07-15-21 - CITY COMMENTS	
--------------------------	--

HOMWOOD SUITES
3500 S. MERIDIAN
SOUTH HILL MALL
PUYALLUP, WA 98373

OFFSITE ADA RAMP IMPROVEMENTS DEMOLITION PLAN
C-3.1

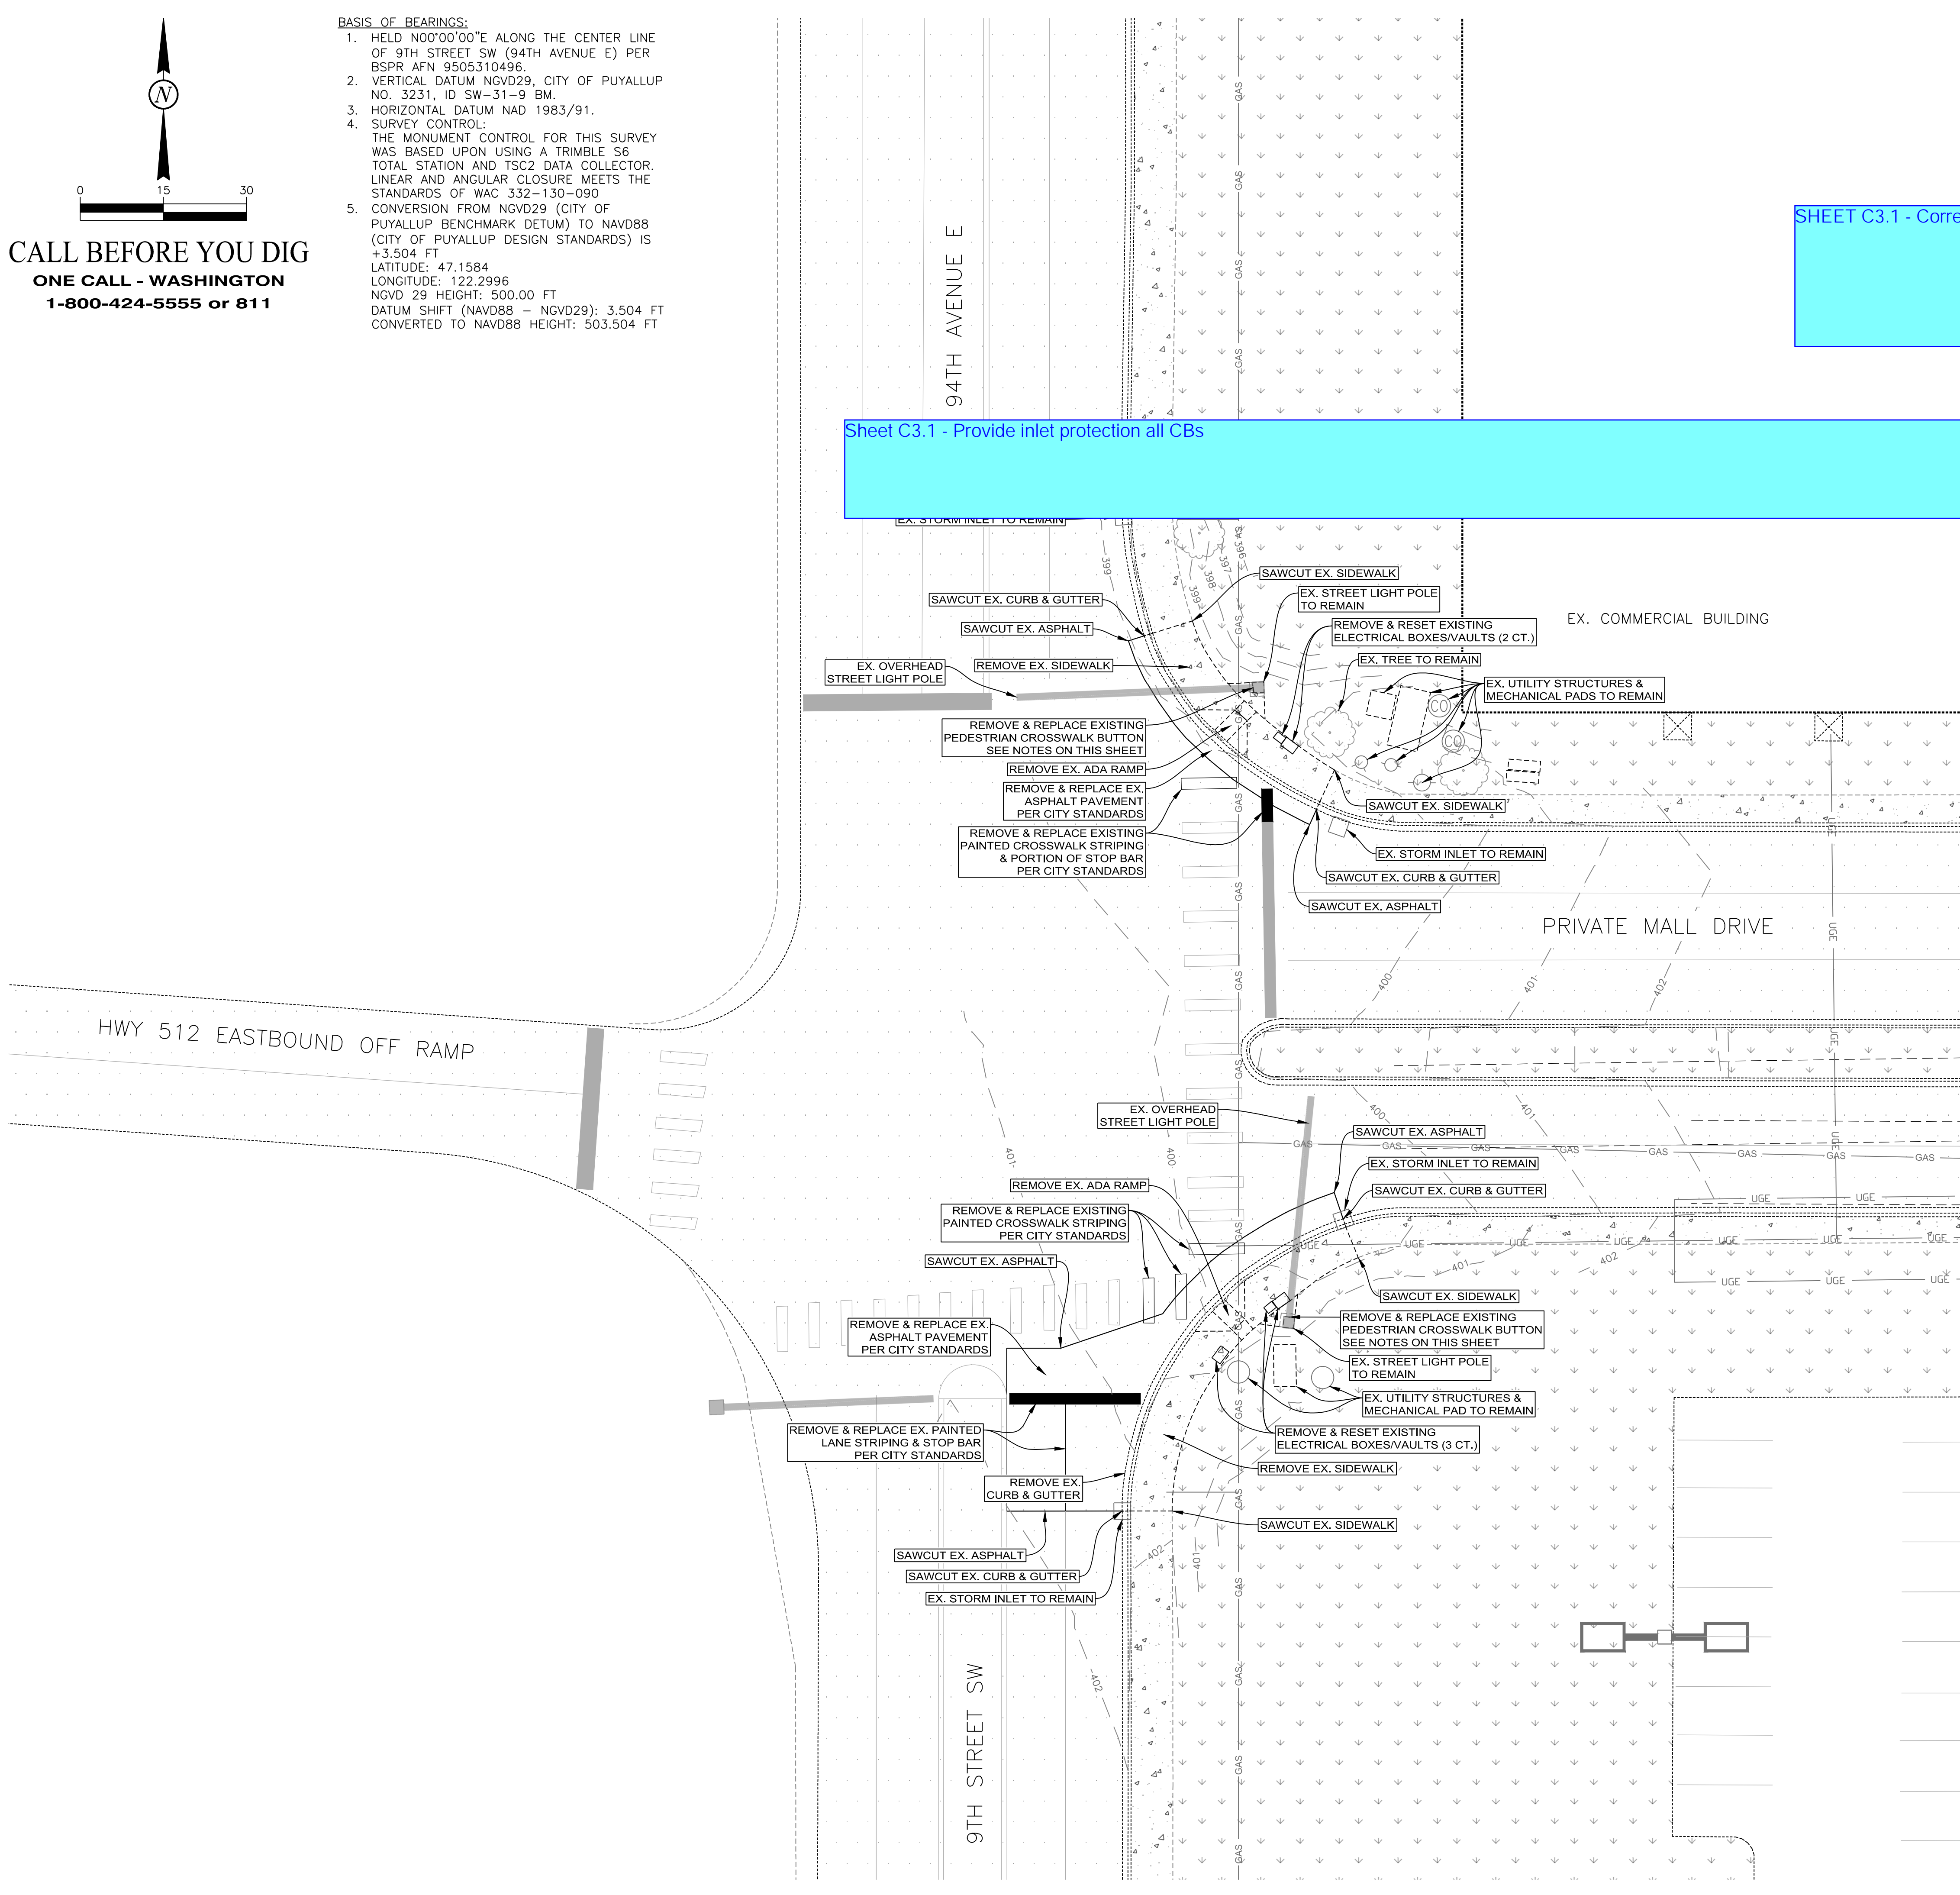
SHEET C3.1 - Correct vicinity map to label road as 94th Ave. E. throughout project area.

Sheet C3.1 - Provide inlet protection all CBs
